Memo

Subject: The Village Precinct, Alphington

As requested, please find below comment on the concept plans submitted for the Village Precinct.

LAWN EDGE 01

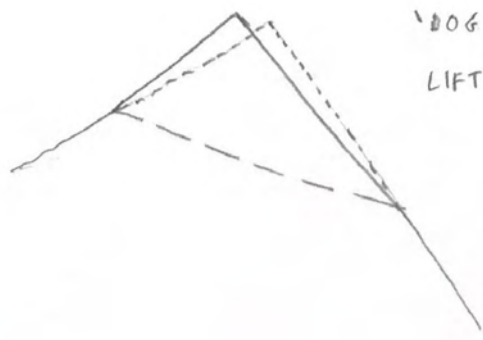
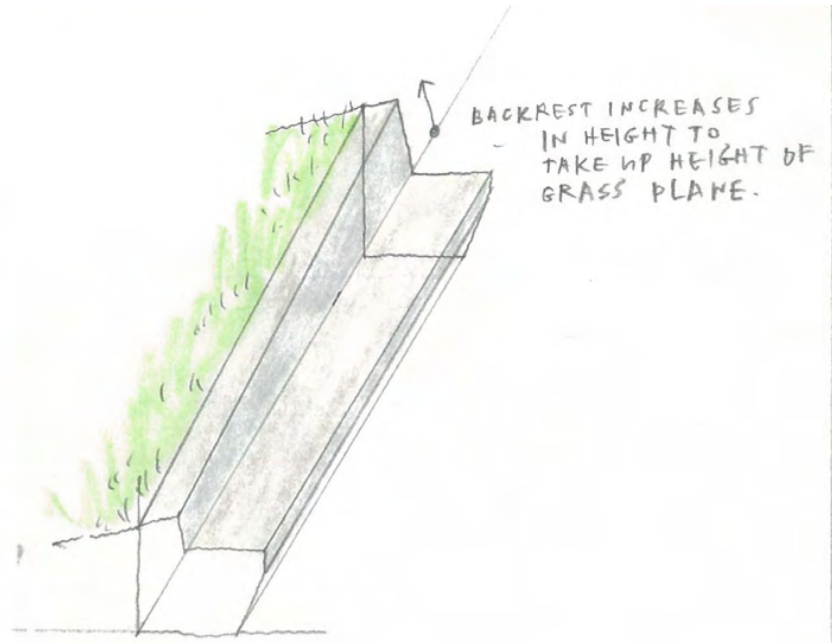
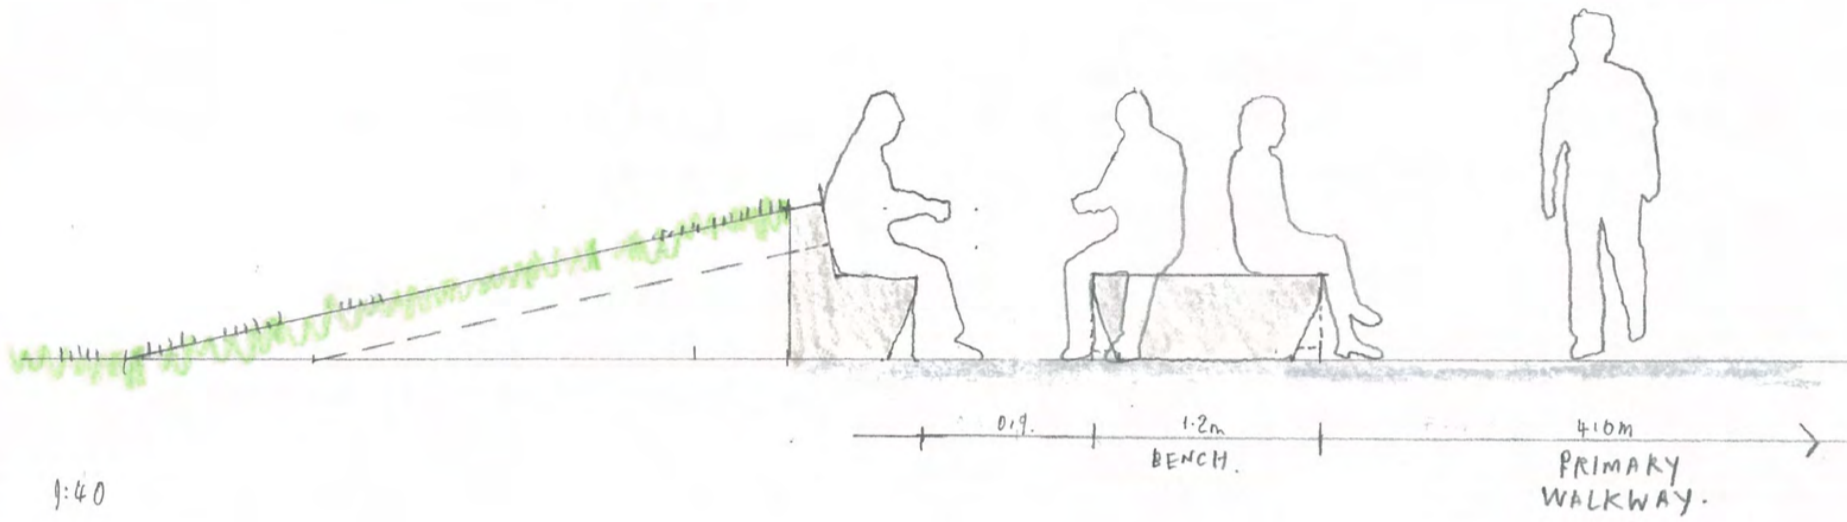
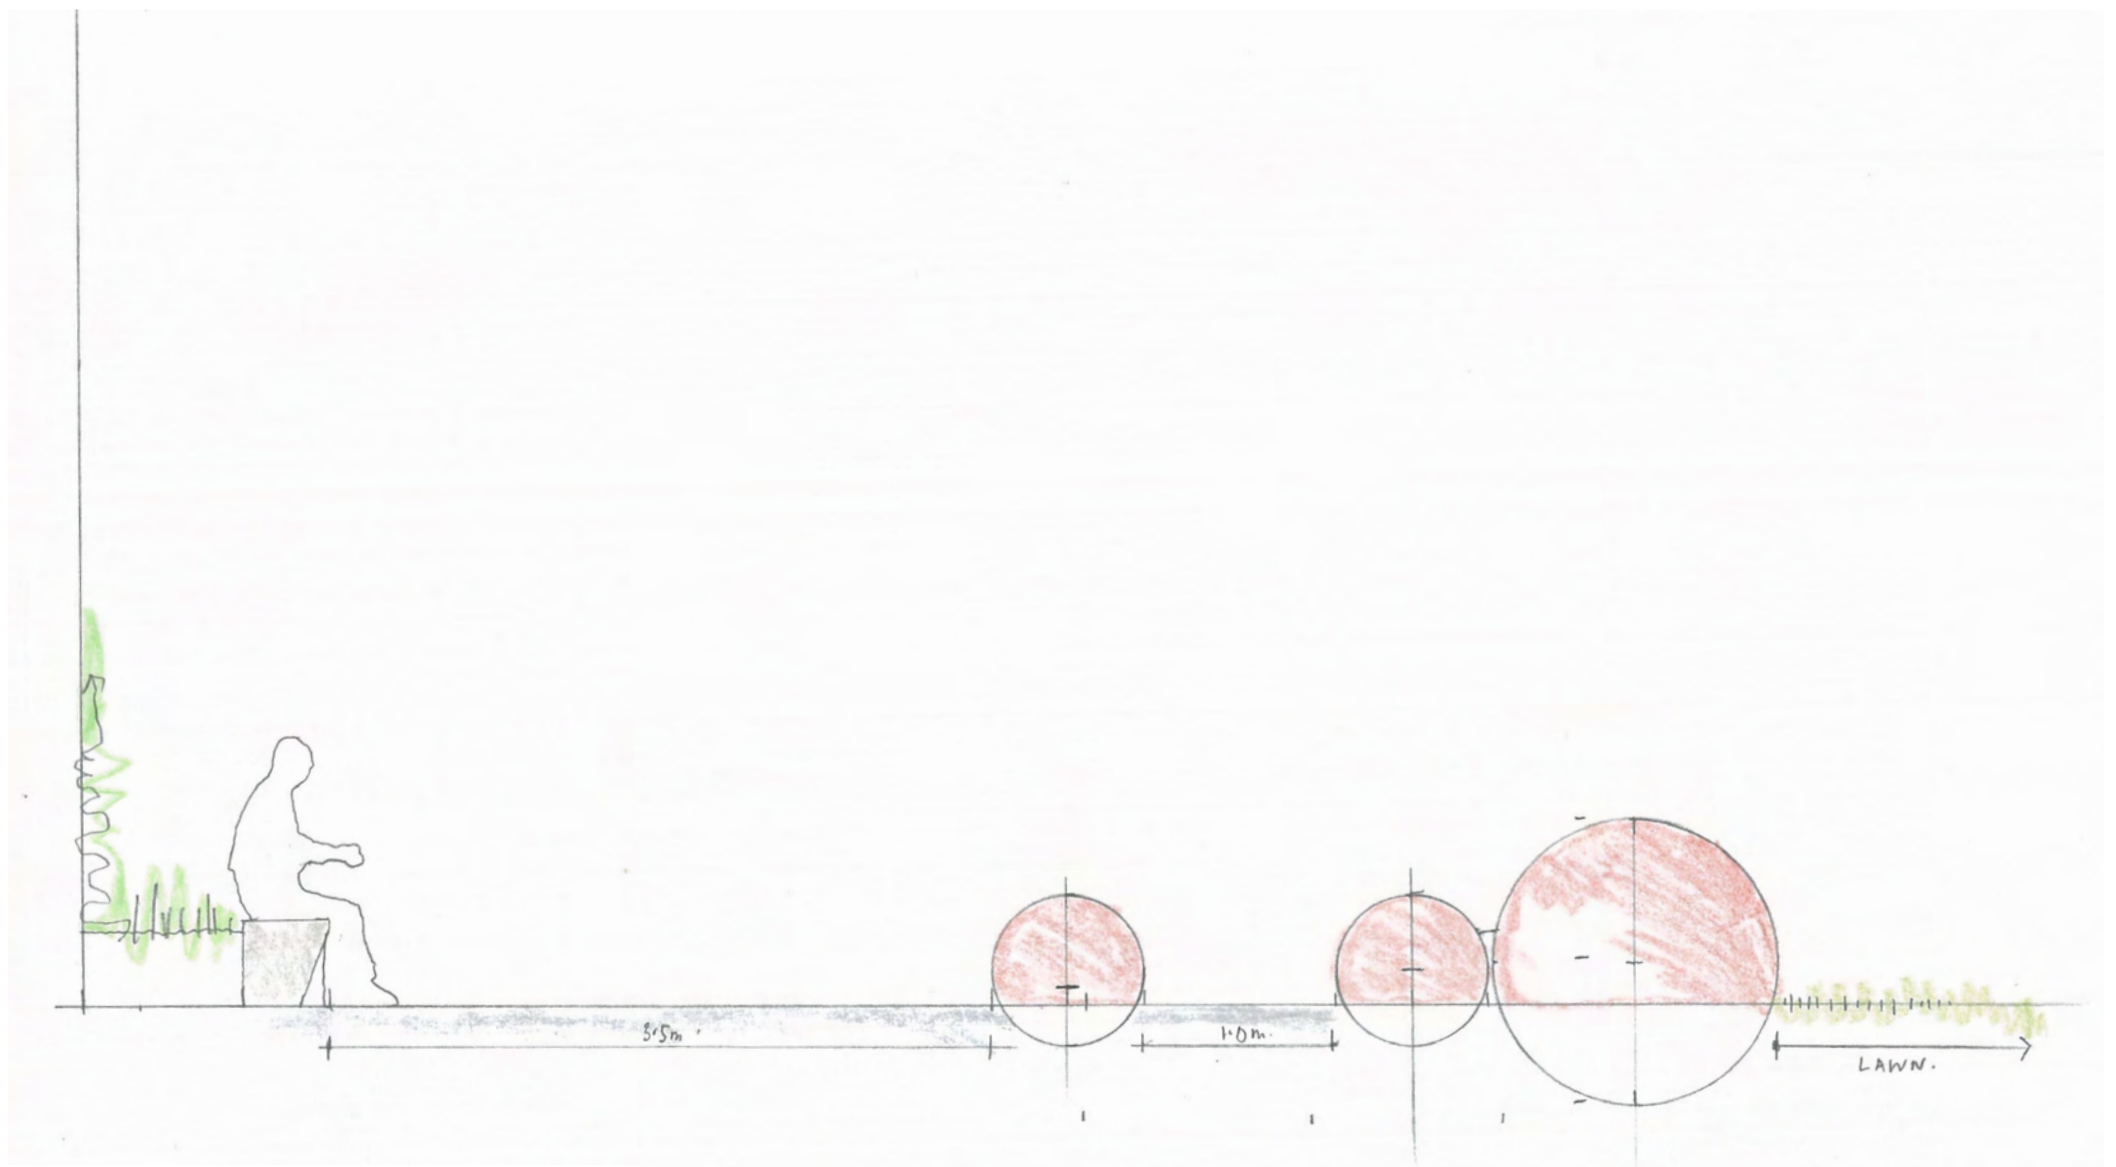
Lawn Edge (Refer to attached Lawn Edge sketch 01 & Section C)

- Explore raising edge to lawn at north-east corner to deter pedestrian desire line through lawn. Create an occupiable edge to encourage occupation of the north-east corner of the square and interface with streetscape. Raised edge may also help to activate lawn (as it may help transition between standing and reclining).

Stair Planter Edge (Refer to attached Lawn Edge sketch 01 and Section D)

- Integrate a seating edge to the raised planter along the staircase to Level 1 Terrace. Creates addition seating along an unused edge that offers long views across plaza. May be useful waiting, meeting location.

Primary Entry Access Path (Refer to attached Lawn Edge sketch 01)

- Primary access path is very generous at 5.5m wide. It is recommended that a 4.0m typical width (with a 3.5m minimum) would accommodate access requirements.

'DOG EAR' CORNER.
LIFT EDGE (SINGLE PLANE)

BACKREST INCREASES
IN HEIGHT TO
TAKE UP HEIGHT OF
GRASS PLANE.

SECTION C
RAISED LAWN & SEATING EDGE

SECTION D
SALVAGED ROLLERS

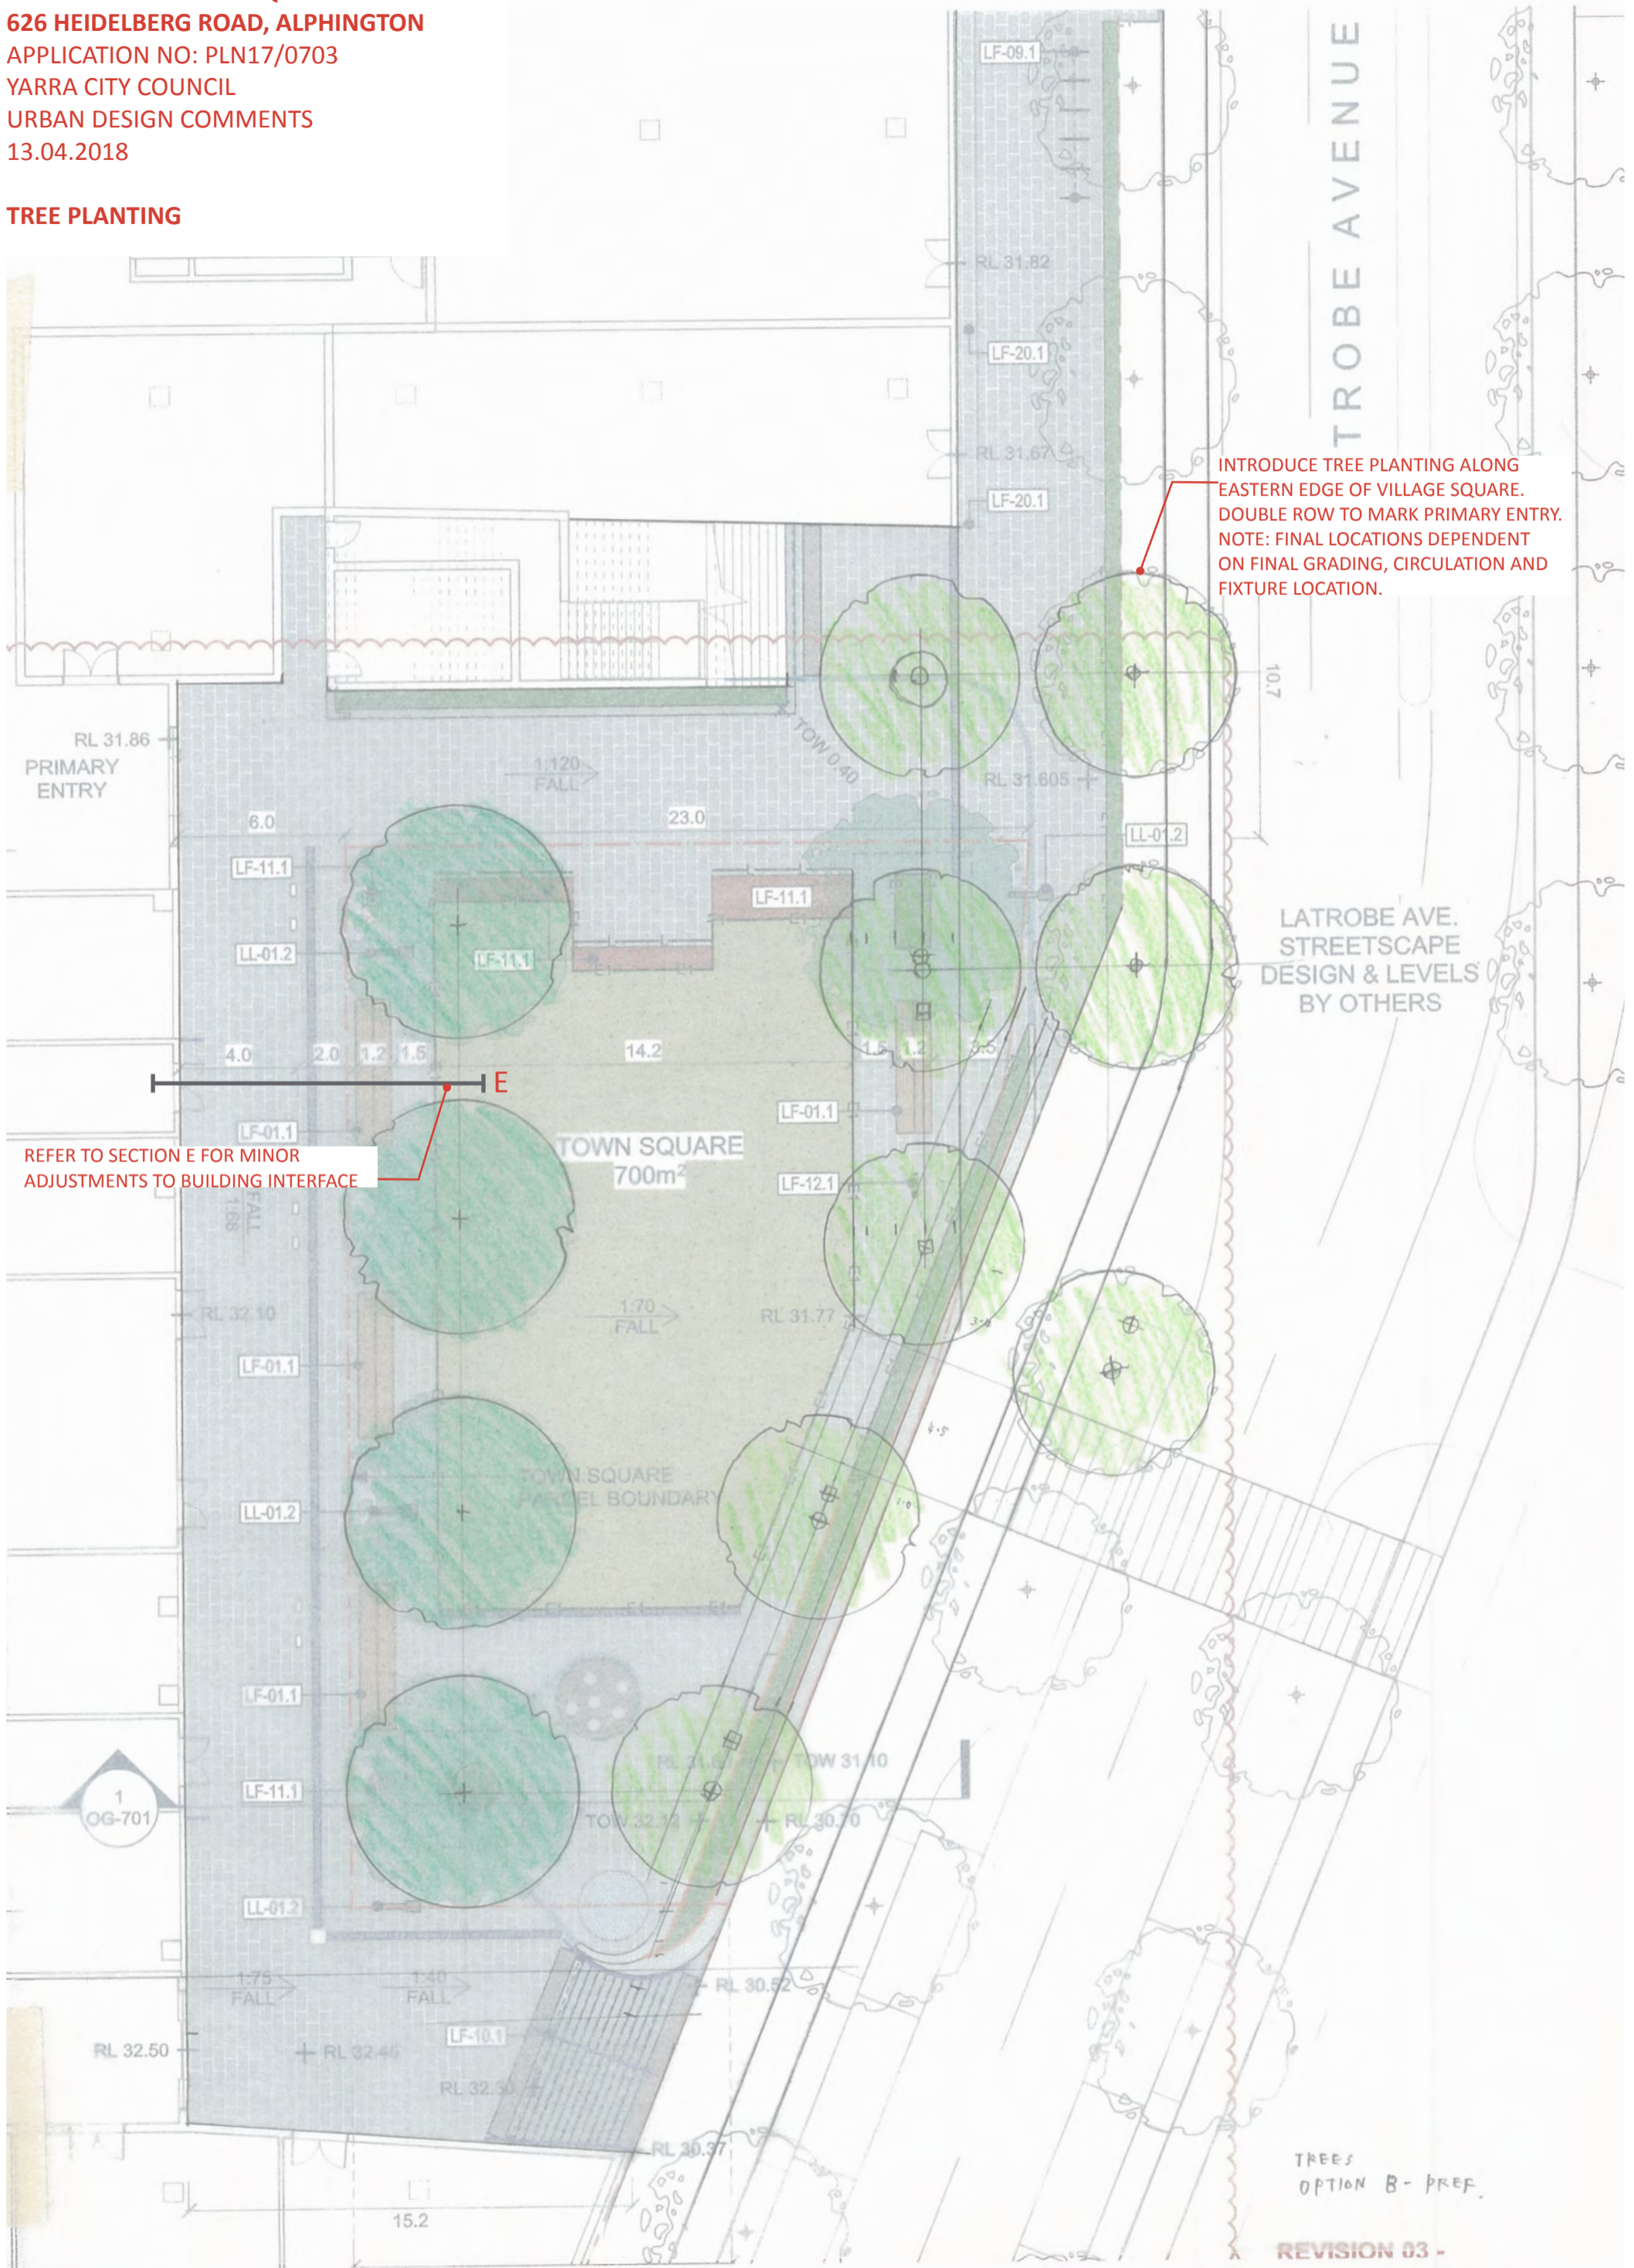
Salvaged Rollers Lawn Edge

- Confirm proposed heights of salvaged rollers with consideration to free height of fall.
